#### **NOTICE OF PLAN COMMISSION MEETING**

- Call to Order/Roll Call
- Approval of Minutes of February 16, 2023
- Discussion & Action on Development Application From DGI-Washburn, LLC for Dollar General Retail Store at 1047 W. Bayfield Street, Tax ID 36169 – Geno Carlson, Petitioner/Agent
  - Architectural Review
  - Site Plan Review
  - Plan of Operation Review
  - Change in Topography Review
- Discussion and Recommendation of City Property Inventory and Land “For Sale” List
- Adjourn

To: Plan Commission Members  
From: Scott J. Kluver, <sup>SK</sup>Administrator  
Re: Architectural, Site Plan, Plan of Operation, and Change in Topography Review of Proposed Dollar General Store at 1047 W. Bayfield Street  
Date: March 9, 2023

DUMPSTER ENCLOSURE SHADOWBOX FENCE

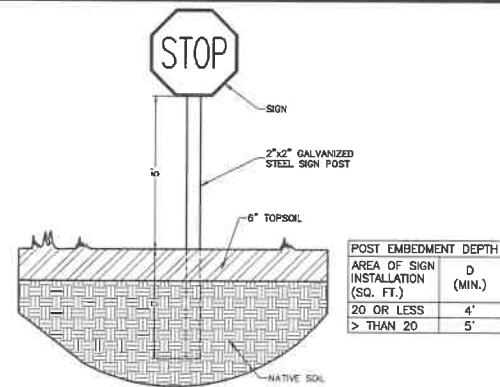
- (7) Fencing shall complement the appearance of buildings onsite. **Fencing is placed around the dumpster enclosure. It is made of wood slats with gaps as depicted on Sheet C6 of the plans.**

DATE: 2/21/23  
 SHEET: **A02**  
 PROJECT NUMBER: DG-22121

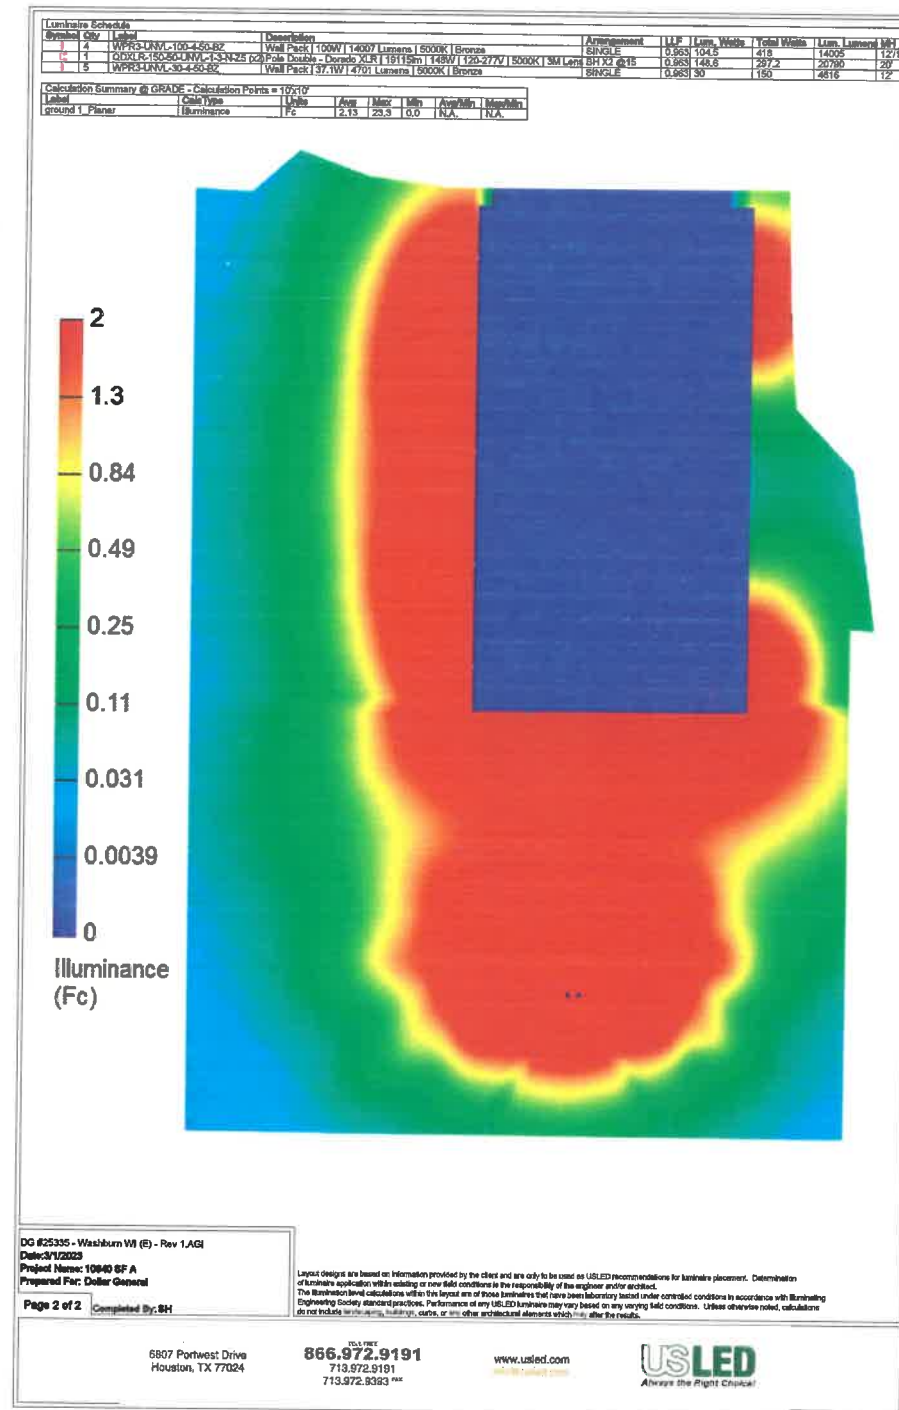
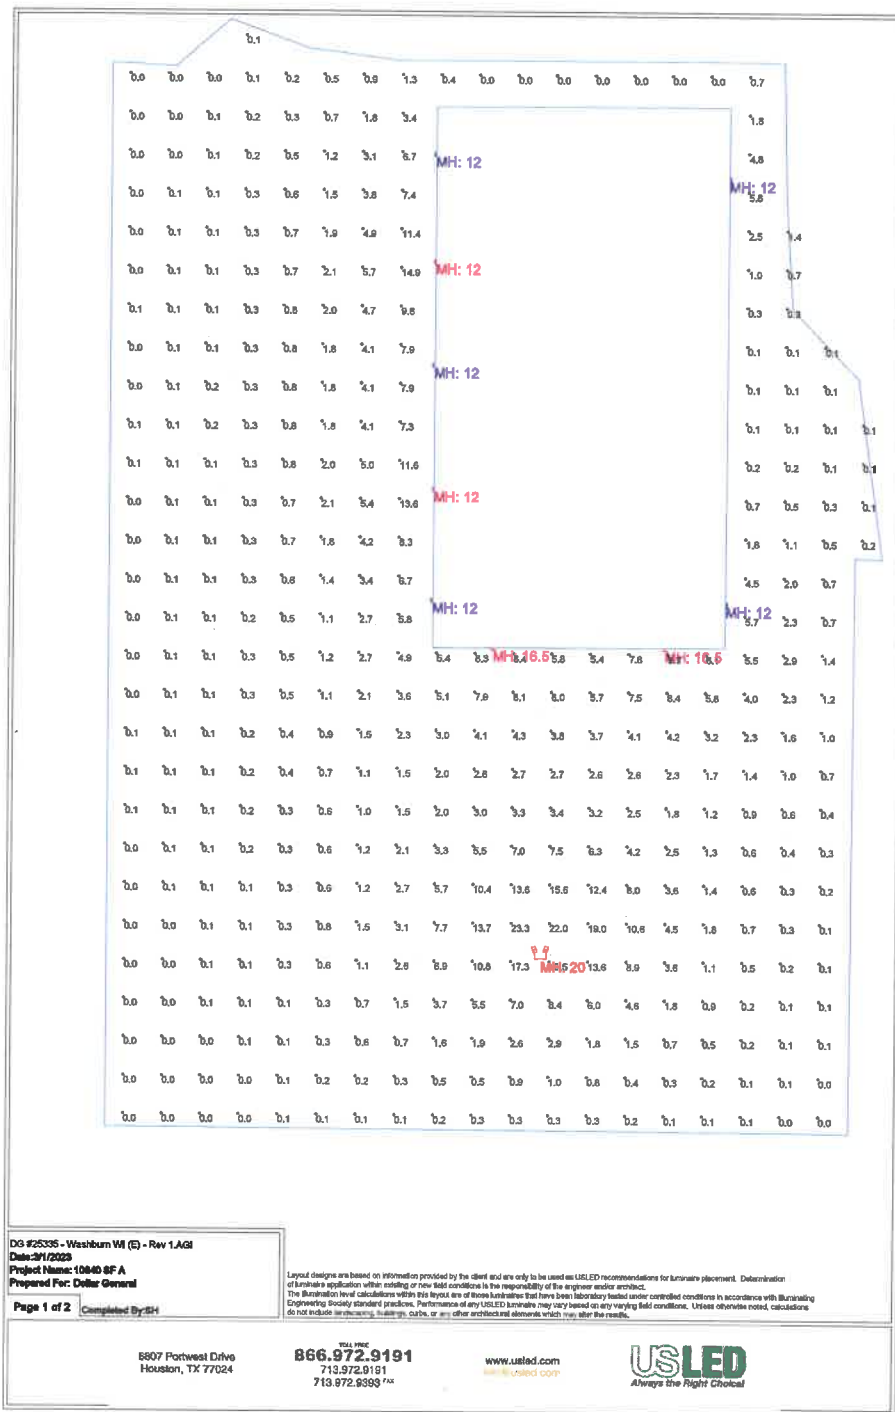
- (1) Excluding residential buildings and Industrial Zoning Districts, all building exteriors facing a street, not including an alleyway, shall have at least 50 percent of the street face constructed with brick, decorative masonry, glass panel, or other appropriate similar finished façade as may be approved by the Plan Commission. Such brick, masonry, glass, or other decorative facing shall extend for a distance of at least 25 feet along the sides of the structure that do not face a street or at least 25 percent of the that side wall distance, whichever is greater. **The south and west elevations, street facing, are at least 50 percent decorative masonry, the north and east elevations are at least 25 percent decorative masonry.**

- (2) Outside of Industrial Zoning Districts, the appearance of any buildings with a front elevation or any building elevation facing Bayfield Street of more than 750 square feet in area shall be divided into distinct planes of 500 square feet or less. The following design features can be used to meet this provision (1) canopies or awnings; (2) arcades; (3) porches; (4) vertical wall offsets having a minimum depth of 8 inches and a minimum width of 10 feet; (5) horizontal offsets having a minimum depth of 2 feet; (6) pilasters having a minimum depth of 8 inches, a minimum width of 12 inches, and a minimum height of 80 percent of the wall height; (7) recessed areas for entryways and the like having a minimum depth of 8 inches; and (8) other suitable multidimensional design features. **The front façade exceeds 750 square feet, but the front entrance area is recessed at least 8 inches for over 10 feet. This will create three distinct planes under 500 square feet.**

- (5) Building entrances must be clearly recognizable from parking lots and pedestrian circulation routes. **Entrances are clearly recognizable.**
  - (6) Rooftop mechanical equipment shall be positioned so it is not readily visible from a public street or an abutting property in a residential zoning district or in a planned development district that allows residential uses. Rooftop mechanical equipment may be placed in an enclosure or screened from view provided such enclosure or screening is used as an element of the building's architecture. **Rooftop HVAC units are present on the structure and are placed on a line near the center of the north/south elevation, and the slope of the roof helps to block the visibility from the west and trees screen the units from the east.**
